TITLE	SCHEMATIC NO.	DATE
			Verde XT 520RS 1GB dHD 1440MB+2x mDP	1GB-C441X3-00	
			REVISION HISTORY	NOTE:	REV
				THIS SCHEMATIC REPRESENTS THE P.O.B. IT DOES NOT REPRESENT ANY SPECIFIC BAY. FOR SCHEMATIC APPROVAL, PLEASE CONTACT THE PRODUCT DESIGNER. PLEASE CONTACT THE PRODUCT DESIGNER FOR ANY CHANGES TO THE SCHEMATIC. PLEASE CONTACT THE PRODUCT DESIGNER FOR ANY CHANGES TO THE SCHEMATIC.	PG3
SC1 REV	PCB REV	DATE	REVISION DESCRIPTION		
A1	001	2011/02/08	Initial Cape Verde XT schematic.		
A2	002	2011/02/08	1. Correct +5VDDC to +5VDDC 2. Add VDDC mode select circuit, which can be use to switch VDDC worked between 1phase, 3phase, 3phase 3. Correct HSVDNC, VSVDNC buffer power connection. 4. Correct U2200 address sequence, (switch MAB0_2 MAB0_3) 5. Add B501, B502 to support Cape Verde PRO without external power connector 6. Update spin fan circuit according to fan board wiring rule 7. Change R190R191R195 to 1.50k package (32200000000) 8. Delete MR54, ADD VR410A, 9. ADD TRIM0 TO PULL UP VR_HOT1.

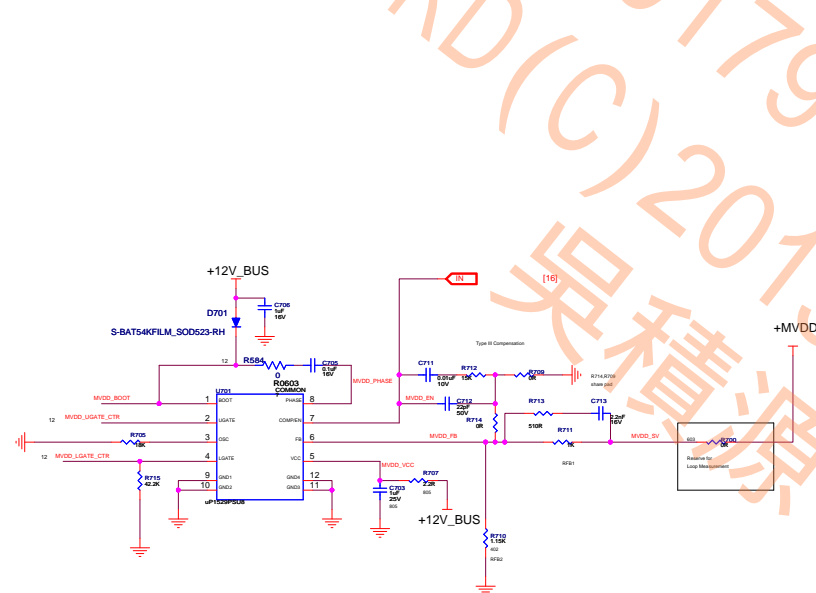
避免IC衝突，先預留0 OHm電阻

Fan Control

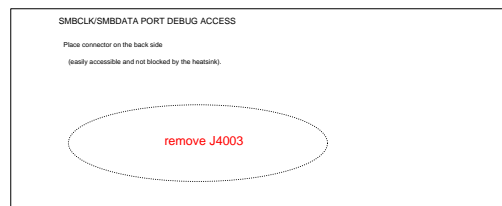
remove 2pin Fan control
